Access Compliance Report

Public Rights-of-Way

(Curb Ramps)

Intersection ID: 14710	Main Street: LYNDHURST_AV	Cross Street: MCDONALD_AV	Location: E
ADA ID: 3971F8286729	Ramp Type: Directional1	Initial Pass/Fail: Fail	Overall Compliance: No
Severity Score: 13.75			
Codes/Mitigation Info/Possible Solution		Field Measurements/Component Compliance

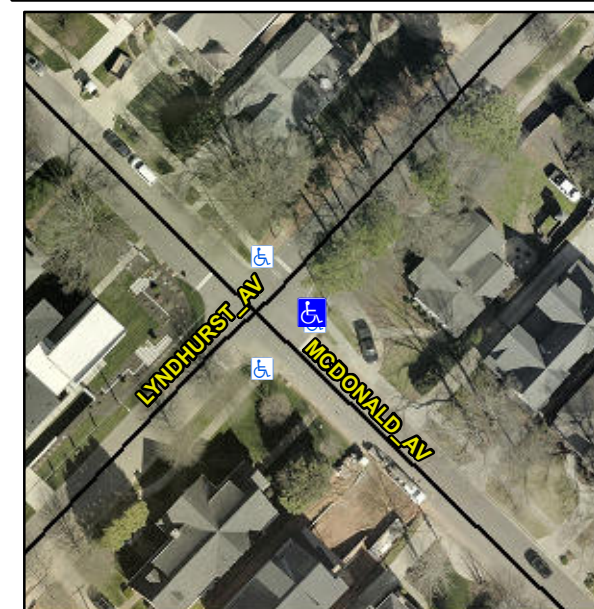
R304.2.2, R304.5.3

Compliance	Description	Data	Compliance	Description	Data
N/A	Ramp Length (in)	140.5	N/A	Grade Break?	N/A
Yes	Ramp Width (in)	54.0	N/A	Grade Break Slope (%)	0.0
No	Ramp Slope (%)	10.6	N/A	Grade Break XSlope (%)	0.0
No	Ramp XSlope (%)	5.0			
N/A	Flare Type LT	N/A	N/A	Flare Type RT	N/A
N/A	Flare Slope LT (%)	N/A	N/A	Flare Slope RT (%)	0.0
N/A	Flare Traversable LT?	N/A	N/A	Flare Traversable RT?	N/A
N/A	Landing Length (in)	0.0	N/A	DWS Provided?	N/A
N/A	Landing Width (in)	0.0	N/A	DWS Contrast?	N/A
N/A	Landing Slope (%)	0.0	N/A	DWS Length (in)	N/A
N/A	Landing X Slope (%)	0.0	N/A	DWS Full Width?	N/A
N/A	Landing Curb? (Y/N)	N/A	N/A	DWS Offset LT (in)	N/A
N/A	Shared Landing?	N/A	N/A	DWS Offset RT (in)	N/A
N/A	Gutter Ponding?	0.0	N/A	Gutter Slope (%)	N/A
N/A	Gutter Lip Ht (in)	1.5	N/A	Gutter X Slope (%)	N/A
N/A	Painted X Walk1?	No		Road Slope (%)	3.6
	X Walk 1 Direction	To NW		Road X Slope (%)	4.0
	X Walk 1 Width (in)	N/A		Clear Space?	N/A

Remove & Replace Entire Ramp.
